## MEMORANDUM

**SUBJECT:** Public hearing and consideration of an application for a Landmark Alteration Certificate to construct a 1,938 sq. ft. addition to the main house, to relocate an existing garage on the property, and to construct a 330 sq. ft. one-car garage at 711 Pine St. in the Mapleton Hill Historic District, per section 9-11-18 of the Boulder Revised Code 1981 (HIS2014-00172).

*Figure 8. Close up of Existing and Proposed Site Plan*

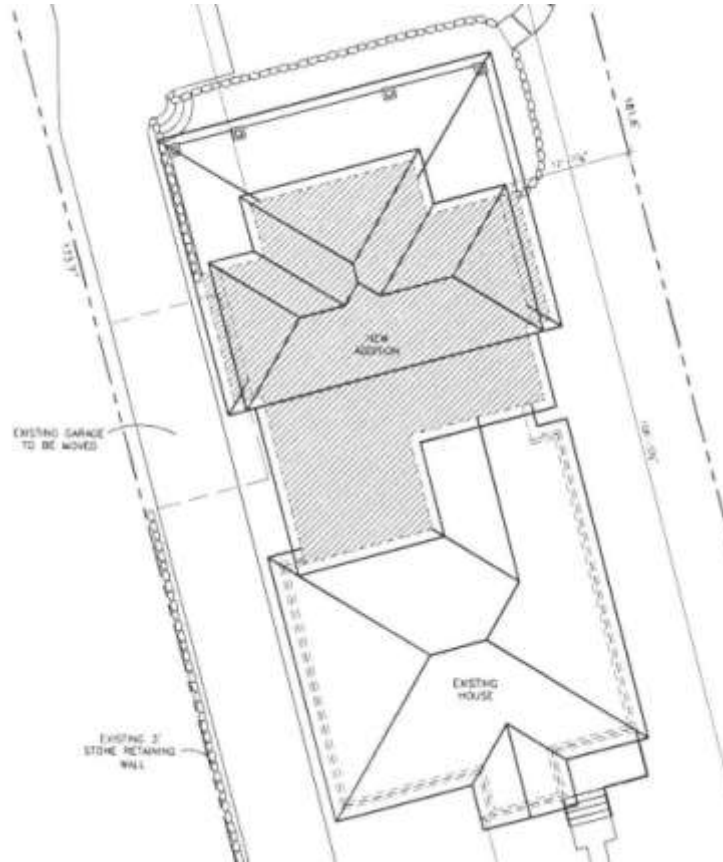
Drawings show a 1,018 sq. ft. addition to be constructed at the rear of the existing 990 sq. ft. house. The first floor will consist of 1,008 sq. ft. and the second floor will consist of 920 sq. ft. The garage currently takes access from the street as the property does not border an alley. This condition is proposed to be maintained with the relocation of the existing garage and construction of a new garage at the west side of the property.

In total, the floor area of the house will be approximately 2,900 sq. ft. with the estimates lot coverage of the house estimated at 1,998 sq. ft. on the 10,323 sq. ft. lot. The application states with the existing and proposed garage, the total floor area (FAR) for the proposal to be 3,493 sq. ft. where the maximum FAR for this property is 4,180 sq. ft.

*Figure 17. Proposed new garage and relocated garage/studio.*

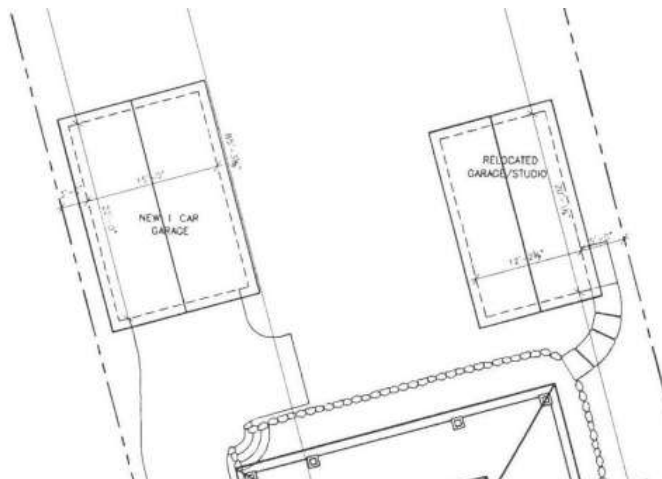
Plans call for the existing 245 sq. ft. garage to be relocated from the west side of the lot to the east side and to be used as a studio. Other than relocation, no changes are shown to be made to the existing garage. A new one car garage of 330 sq. ft. will be constructed behind the house by the west fence line. Because of the slope of the lot, the simple gable end building is shown to be bermed into the ground at the north. Fenestration consists of a simple wood automobile door at the south with a man door and single light casement window on the east face of the building. Plans call for the new building to be sheathed in wood clapboard siding and board and batten to match the proposed addition.
